Authorized Field Change

AFC 17904

Subject: Update Instrument Cluster, Body Control Module (BCM), Light Control Module (LCM), Switch Pack Modules, and Stalk Shifter Module

Model: Certain International® LT™ Series and RH™ Series model trucks built 01 June 2015 through 14 August 2017.

Figure 1. Detected Modules: Before Update

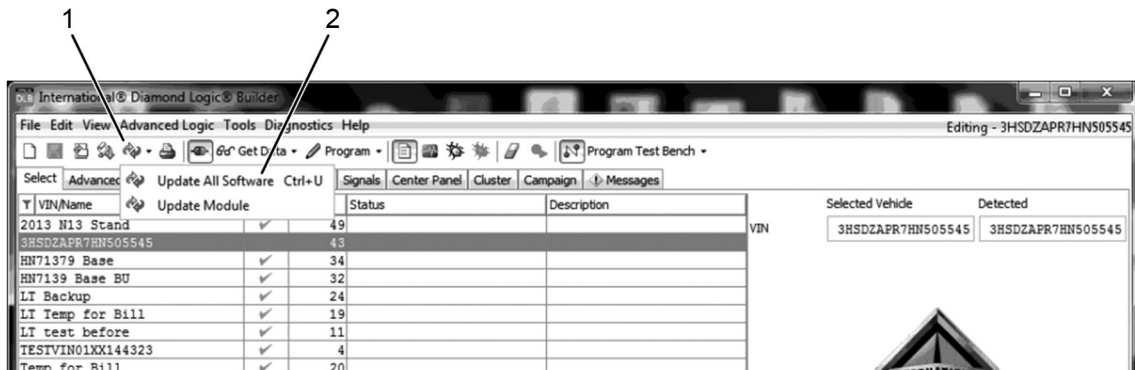
7. Select the Detected Modules tab (Figure 1, Item 1) to see the kernel information for this vehicle.
8. If the Detected Kernel and Kernel columns are not displayed, enable their display by right clicking on any column heading (Figure 1, Item 2) and then selecting these columns in the right-click menu.

Figure 2. Update All

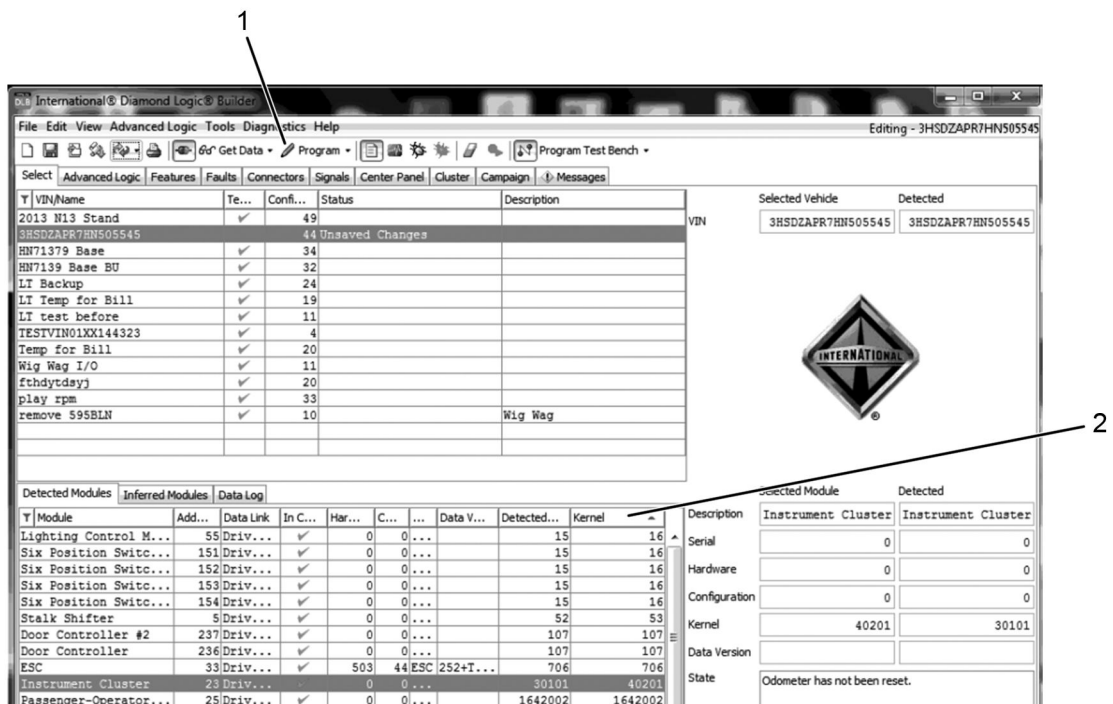
9. Click the Update All icon in the toolbar (Figure 2, Item 1) and select the Update All Software option (Figure 2, Item 2). DLB will update the versions displayed in the Kernel column to the latest versions available.

Figure 4. Programming Complete

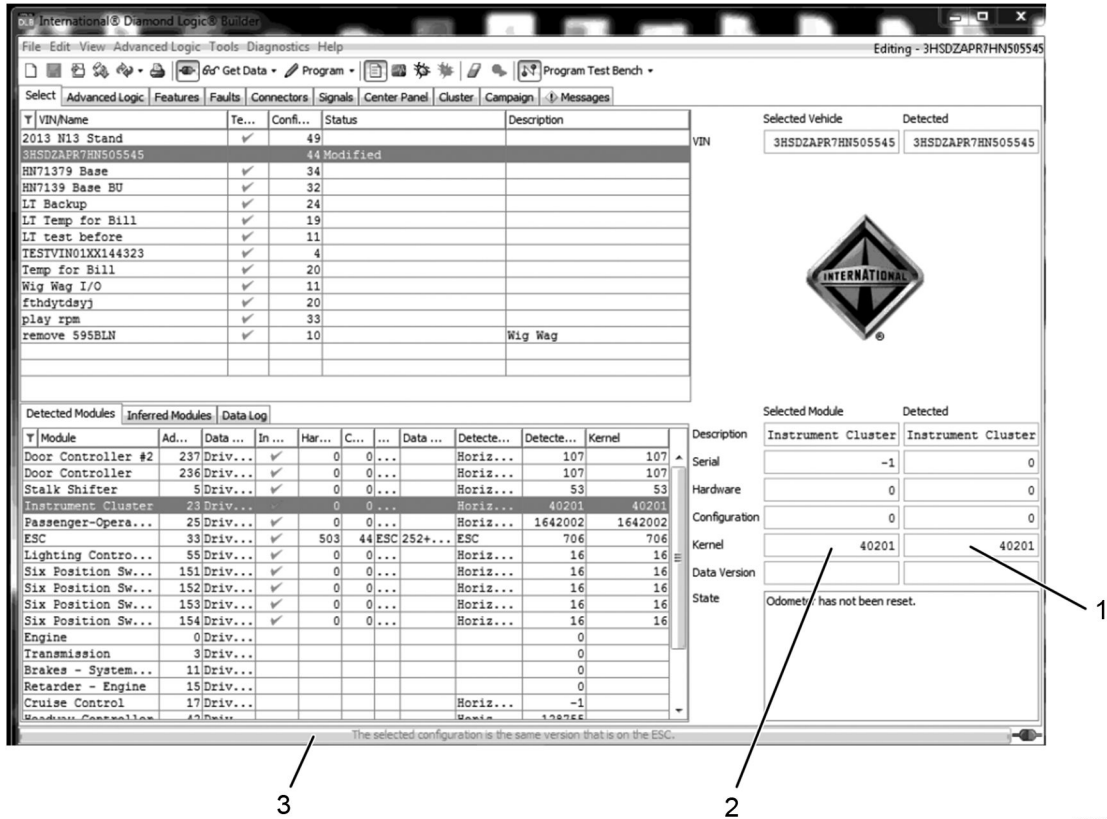
13. Verify that programming is complete by selecting each updated module. If the update has been finished for the selected module, the kernel version listed in the Selected Module column (Figure 4, Item 2) will match the version listed in the Detected column (Figure 4, Item 1). Additionally, the status bar at the bottom of the window (Figure 4, Item 3) will display “The selected configuration is the same that is on the ESC.”
